Building plan.

43. M.P. 1. Napier St.

ORDER UNDER SECTION 96 (2) OF ACT, III OF 1901.

With reference to ^{his}~~their~~ application dated...10/X/28...with aplan for the proposed ^{Building}~~additions~~ on plot No. 26...Survey Sheet No. A-20

The plan showing the Shops with
upper stories to be built on plot
No. 26. A 20 Napier Qr
after leaving the alignment portions
of both of the Streets as desired
Scale 8 Feet to One Inch.
Kamalram Goudandas

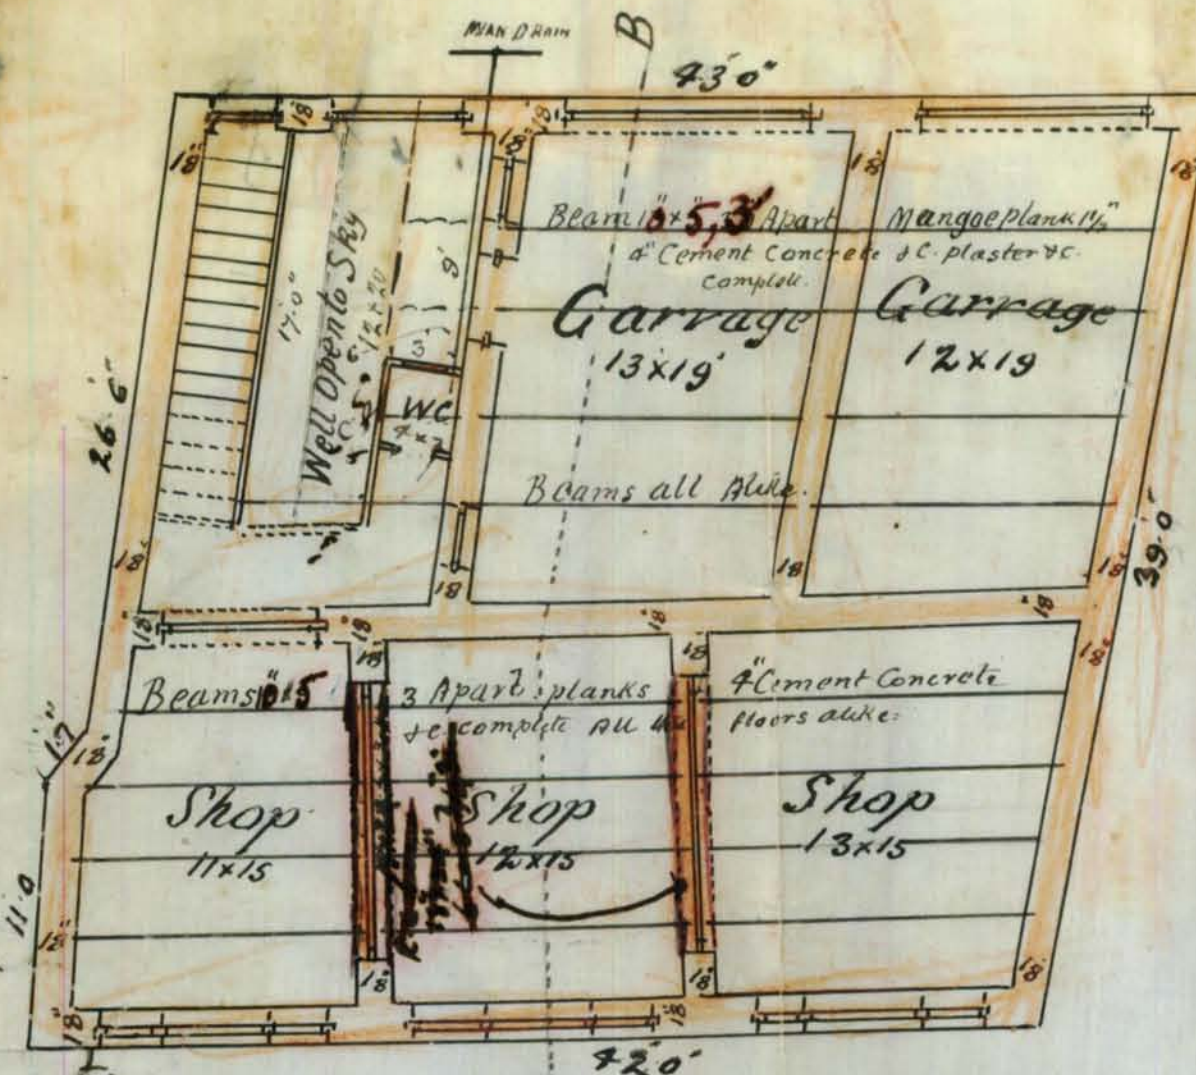
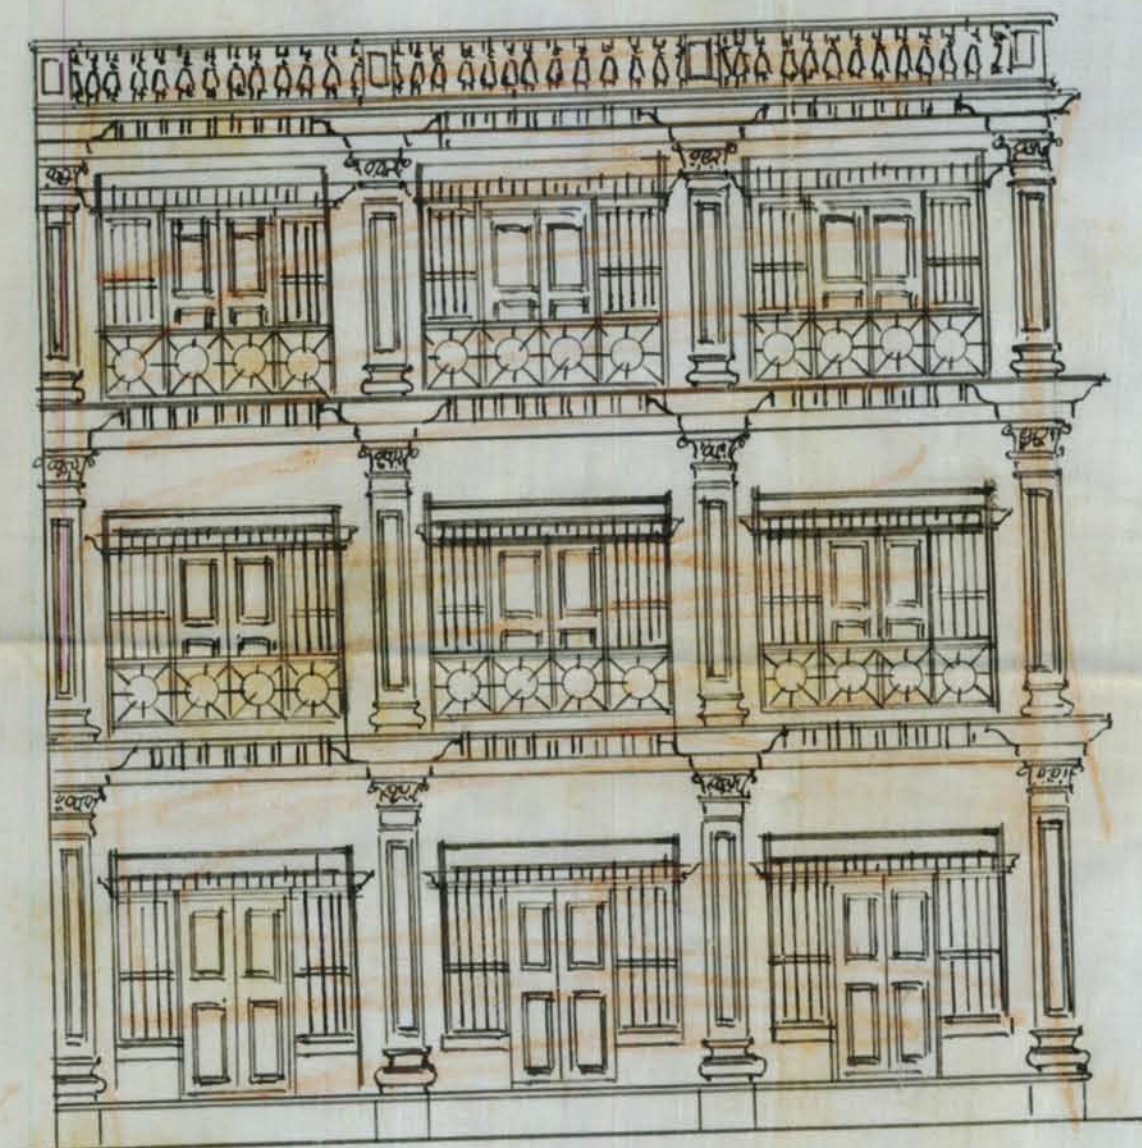
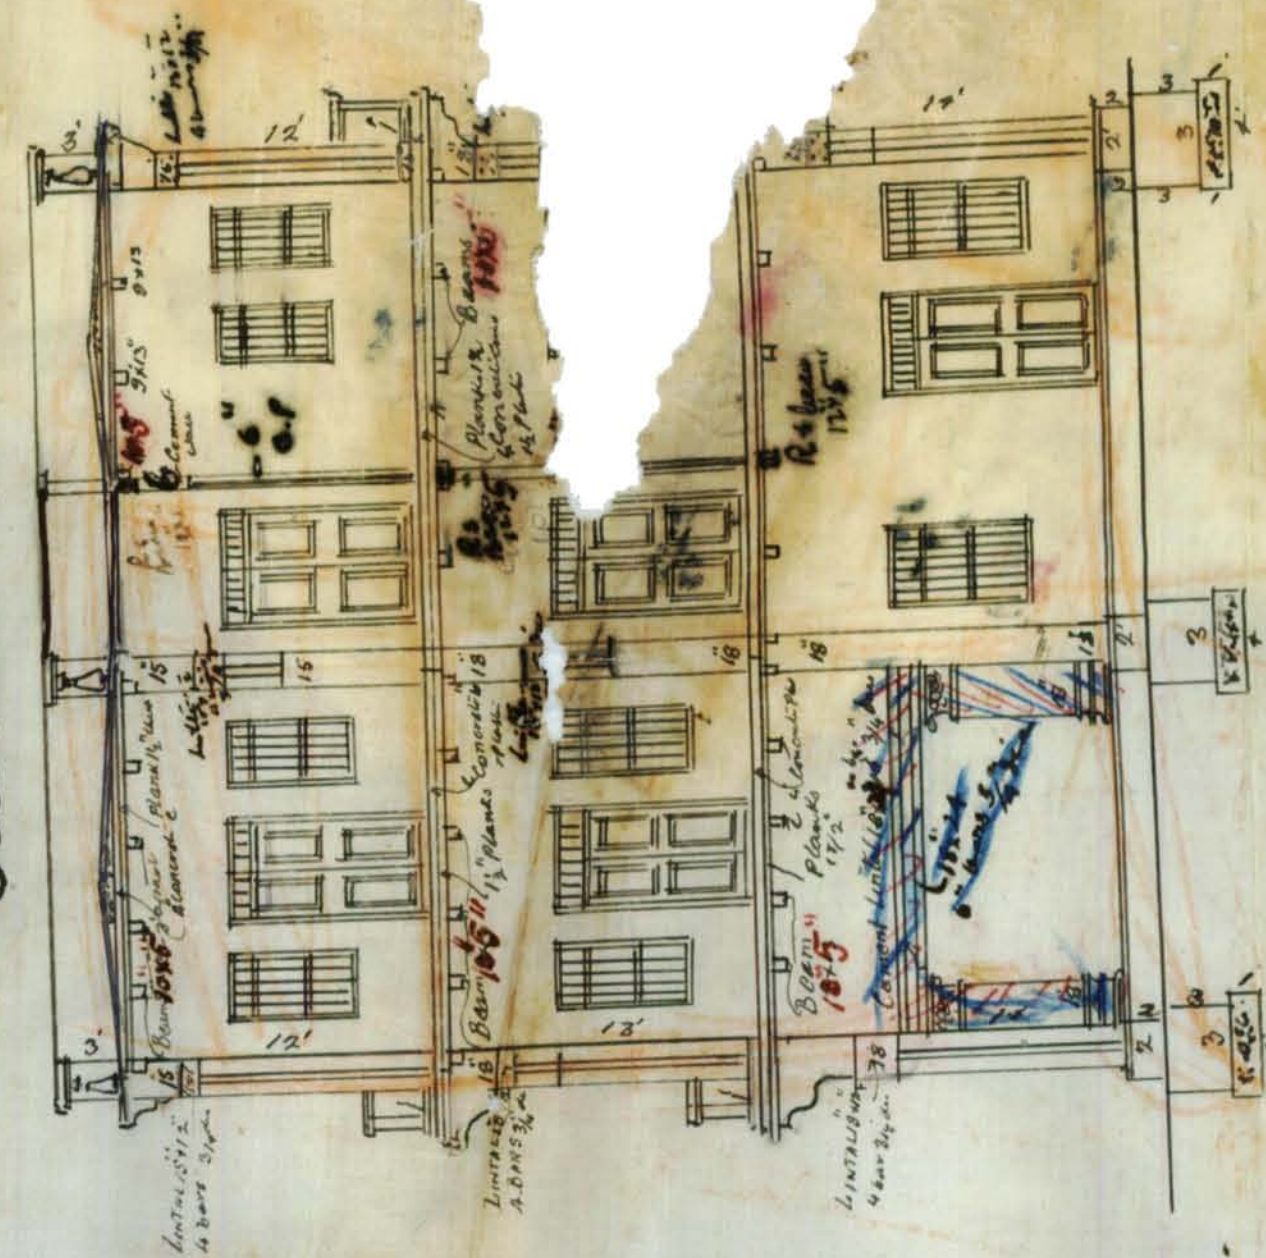
Building Surveyor's Report (1) open to my spaces to be diminished.

(2) WCs on all floors require to be rearranged. It is suggested that they may be shifted to the position marked A.

W.C over Shop cannot be allowed. I comment

(3) Joint arrangement of passages must be shown on plan. And so also of Kitchens & Sanitary block.

(4) Section must be corrected.

(5) Drills must be provided.

(6) Calculations for R.C. beams marked 'B' must be given. The size of reinforcement to be increased.

(7) Drainage connection must be shown on plan

Calculations for R.C beam

Hence the 24" depth assumed is quite all right

Hence steel to be used = 6 bars $\frac{3}{4}$ " diam

- ✓ (1) Open to sky space must be dimensioned
- (2) W.C. over shop cannot be allowed
- ✓ (3) Joint arrangement of passages must be shown on plan and so also of kitchen & sanitary block.
- ✓ (4) Section must be corrected.
- ✓ (5) Lintels must be provided.
- ✓ (6) Calculations for R.C.C. beams marked 'R' must be given. Also size & reinforcement required to be increased.
- ✓ (7) Drainage connection must be shown on plan.
- (8)
- (9)

—The plan showing the shops—
 —and houses are to be rebuilt on—
 —plot No 26. Surrey Sheet N^o A 20—
 —NAPIER QUARTER—
 —Scale 8 feet to One inch—

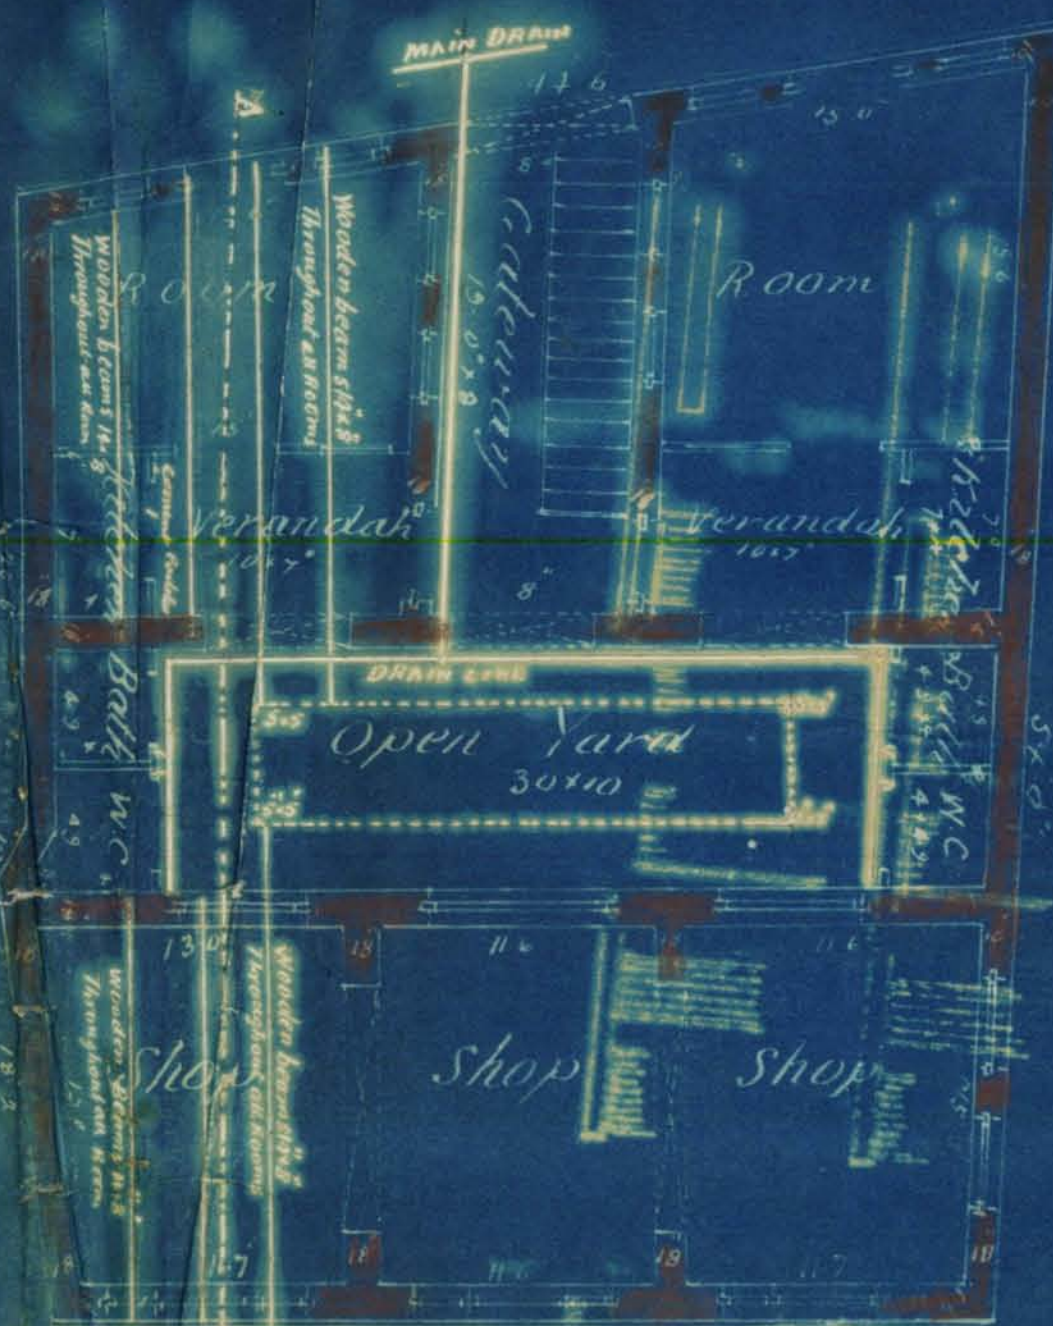
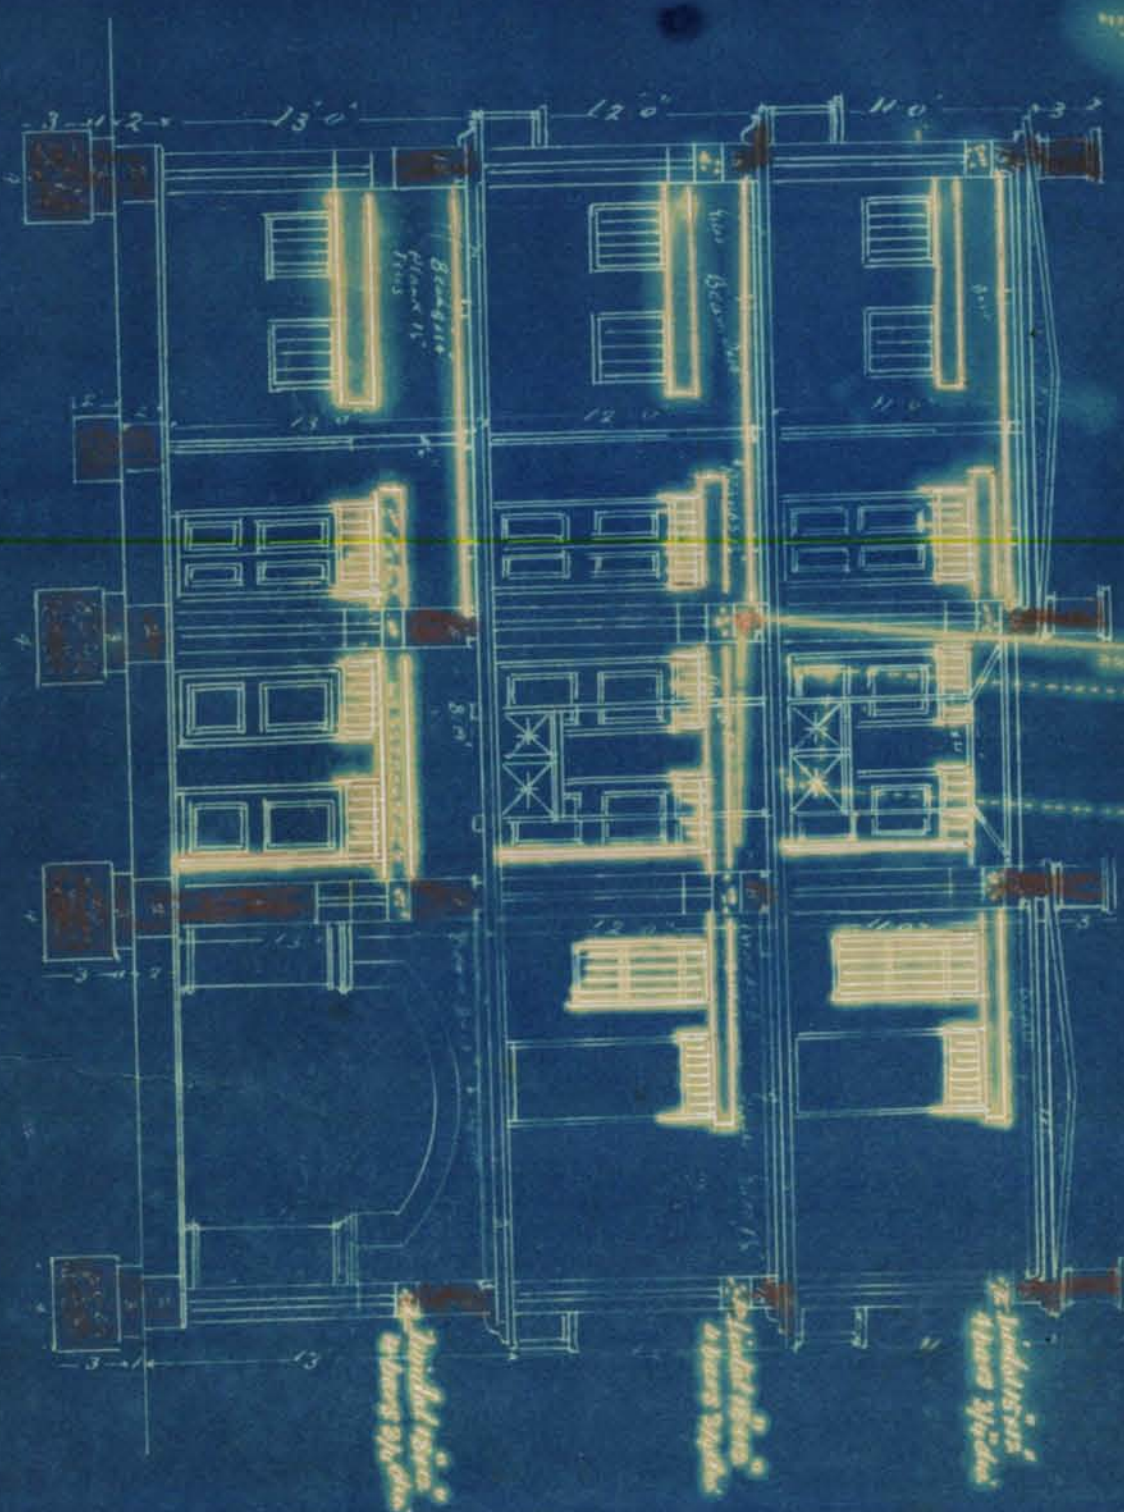
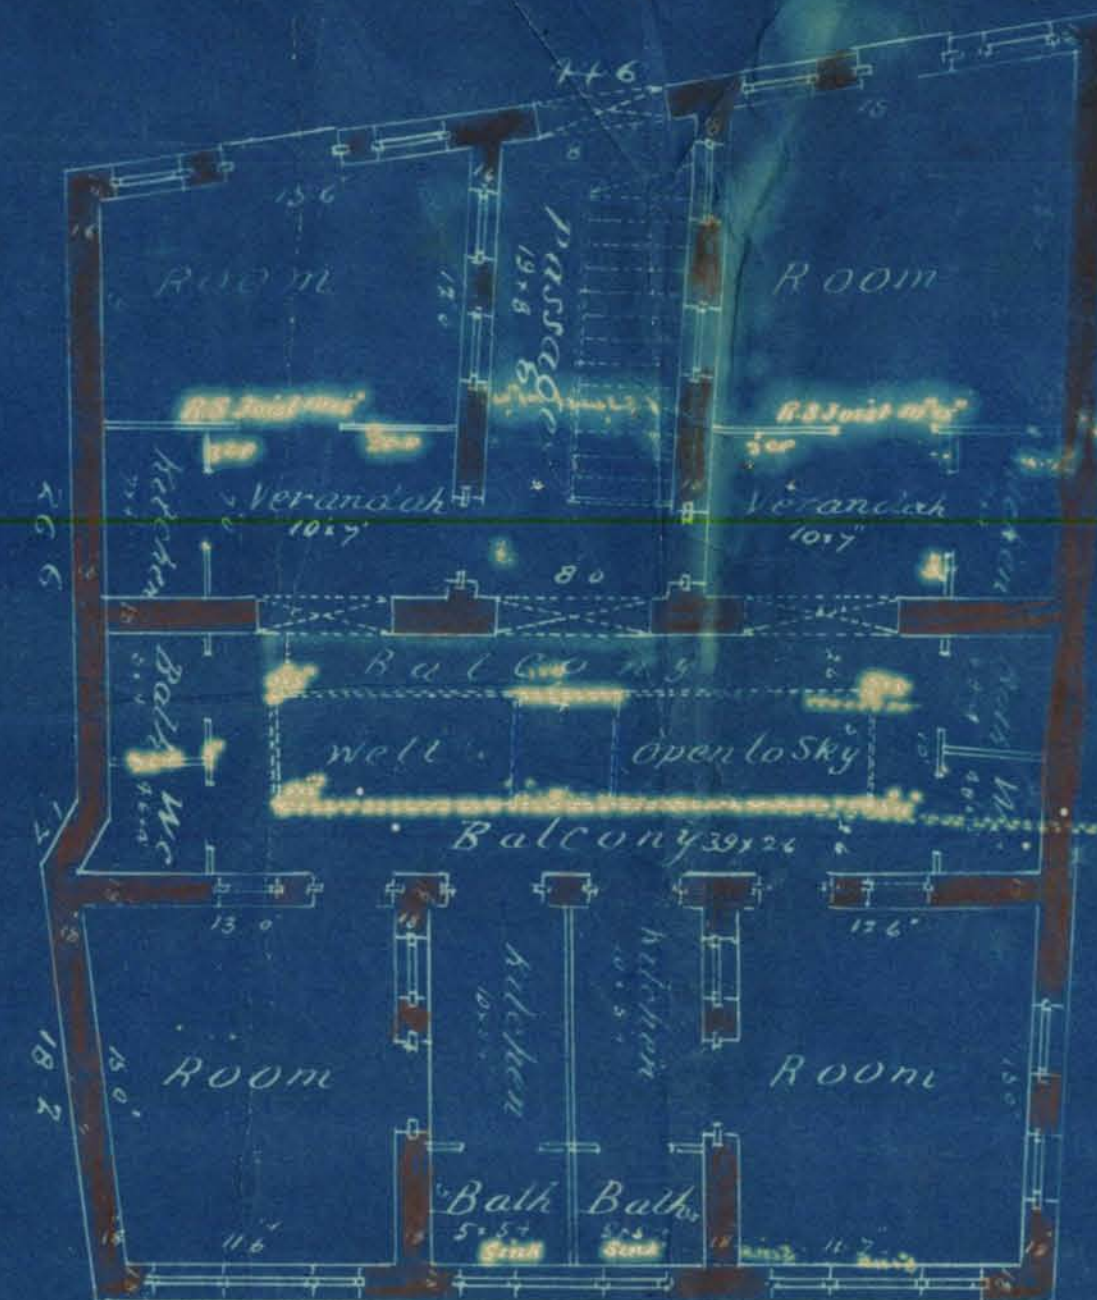
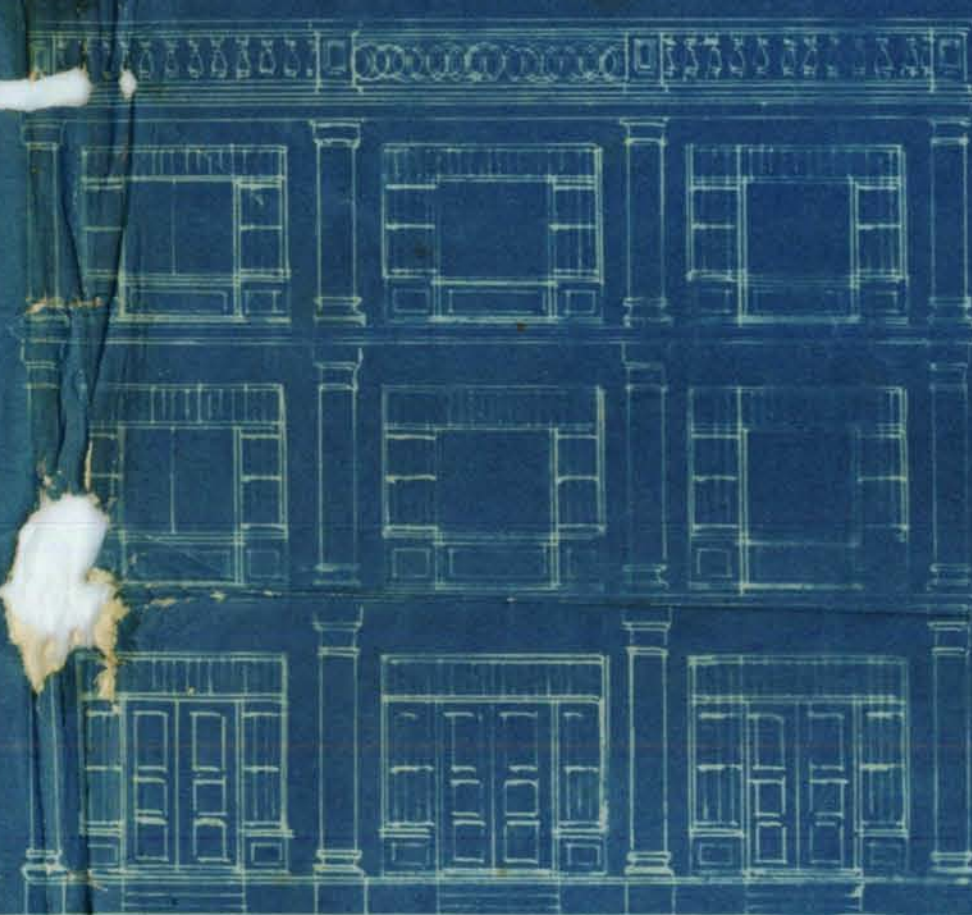
- (1) For 15' span wooden beam may be 11" x 5" as 14" x 8" beams are too big.
- (2) Alignment on Haji Abdullah Street is under consideration.
- (3) The application to build must be made on new form (A) under section 26 modified.
- (4) Zero points must be distinct.
- (5) Beam arrangement must be shown on 1st and 2nd floor plan.
- (6) Lintel must be fully detailed.
- (7) Area left under alignment will be checked after it is left therefore the area of 37-86 sq yds must be deleted.
- (8) Open yards must be at least 8' clear in width free from any obstruction.
- (9)

Applicant's Name Mr. Kewaham SardhandanWhether he is the owner of the plot on which it is proposed to build yesPlot under whose control GovernmentWhether it is permanent or temporary permanentThe work proposed BuildingBuilding Surveyor's Report (1) The application to build must be made under new form (A)(2) Ferro print must be distinguish.(3) Beam arrangement must be shown on 1st-2nd floor plan.X (4) For 15' span size of R.S. piers must be 12x5" instead of 10x5"(5) Details must be fully detailed.Date 25/6/28

for 15' span work been made 11' x 5'
14' x 8' beams are too big & will probably be
never used in actual construction
Alignment on Hapi Abree should be
under consideration, BS 1.65 has 4' x 4'
area under aligner which checked after
it is less than the area of 37.86 must be
deleted. Open yard must be at least 8' clear
in width from any obstructions
